Application No.	Applicant(s)			
Office Action S		10/692,141	SHENGHAO ET AL.			
Office Action S	ummary	Examiner	Art Unit			
		Noah C. Hawk	3637			
The MAILING DATE of this communication appears on the cover sheet with the correspondence address Period for Reply						
A SHORTENED STATUTORY PERIOD FOR REPLY IS SET TO EXPIRE 3 MONTH(S) OR THIRTY (30) DAYS, WHICHEVER IS LONGER, FROM THE MAILING DATE OF THIS COMMUNICATION. - Extensions of time may be available under the provisions of 37 CFR 1.136(a). In no event, however, may a reply be timely filed after SIX (6) MONTHS from the mailing date of this communication. - If NO period for reply is specified above, the maximum statutory period will apply and will expire SIX (6) MONTHS from the mailing date of this communication. - Failure to reply within the set or extended period for reply will, by statute, cause the application to become ABANDONED (35 U.S.C. § 133). Any reply received by the Office later than three months after the mailing date of this communication, even if timely filed, may reduce any earned patent term adjustment. See 37 CFR 1.704(b).

DETAILED ACTION

Buono, Figure 4

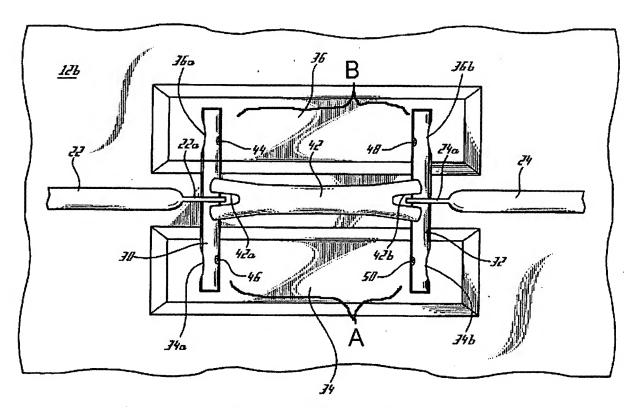
a. Regarding Claim 1, Buono discloses a table comprising a table top (12) having a top surface (12a) and a bottom surface (12b), a mounting structure (34,

36) centrally disposed on the bottom surface of the table top, a support assembly

(A, B, 30, 32) at least partially connected to the mounting structure, a frame

assembly comprising a first leg (14a) connected to the bottom surface of the

table top and a support brace (24, 28a, 28b) having a first end and a second end,

the first end being attached to the first leg and the second end being attached to

the support assembly and at least one handle (42) disposed underneath the

bottom surface of the table top.
